# CITY OF MIAMI

## ADDENDUM NO. 2

**NORTH POLICE SUBSTATION HURRICANE PROTECTION UPGRADE PROJECT CIP**

**SOUTH POLICE SUBSTATION HURRICANE PROTECTION UPGRADE PROJECT**

**SK-01**  
DRAWING NO.

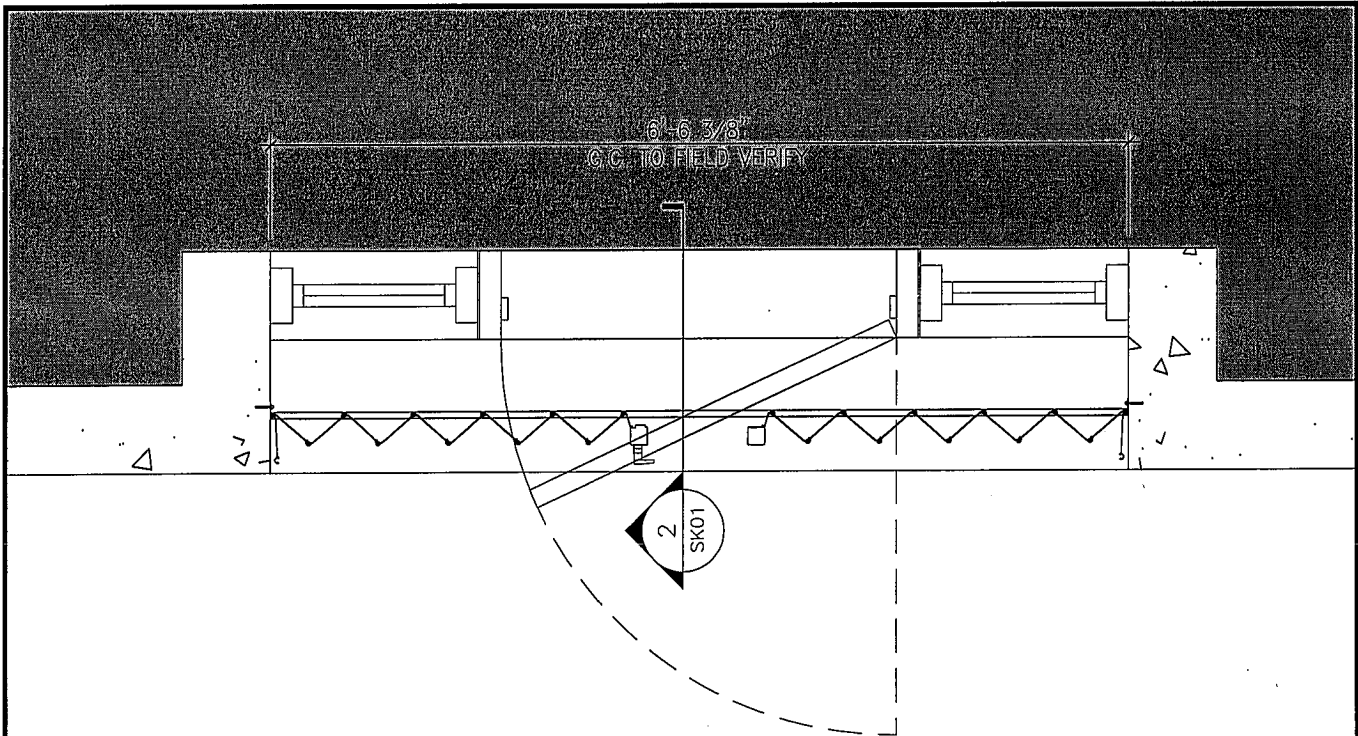
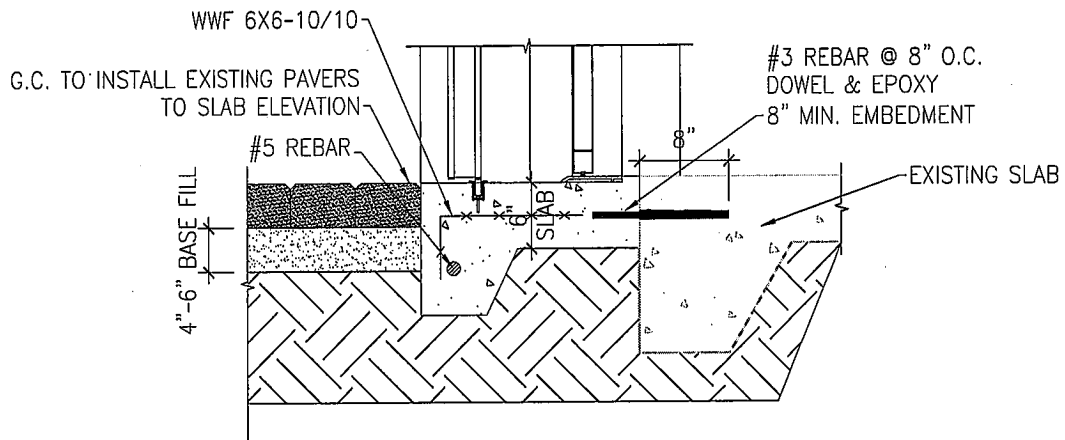
1. Please find attached as a part of this Addendum the sign-in sheet from the Pre-Bid meeting.
2. Please find attached the Architect's clarifying Slab Extension drawing regarding the southwest facade entrance and the need to secure the required track for the accordion shutters;

**1 Enlarged Plan**  
SCALE: 3/4"=1'-0"

**2 Section**  
SCALE: 3/4"=1'-0"
